SKEP III Home Office Support Site Visit Report

Consultant	Wahib Medanat Consultant Engineer	Rep No.	13-16082021
Contractor	Derar Saraireh & Sons for Engineering & Contracting	Tender No.	(11/2019/USAID/SKEP/3/S) Schools for a Knowledge Economy Project (SKEP) - Phase (3) Package (1, 2)
Site Name	Khadija Bint Khwailed Basic Mixed School- Shouna Janoubia	Day/ Date	Mon. 16/08/2021
Duration of Project	450 Calendar Days	Total Project Budget	9,789,417.840 JD

(Figure: 09)

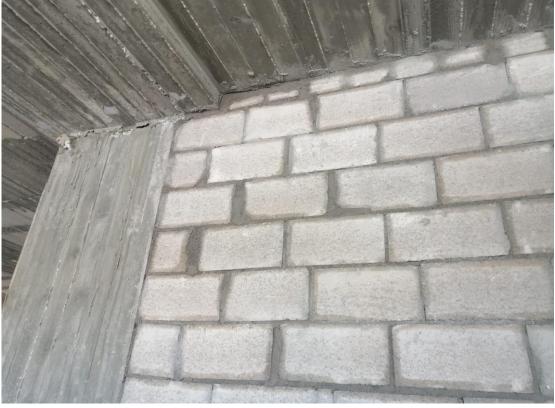
It was observed that the Contractor followed the right procedure in rectifying the defects in casted concrete for walls using the approved repair materials
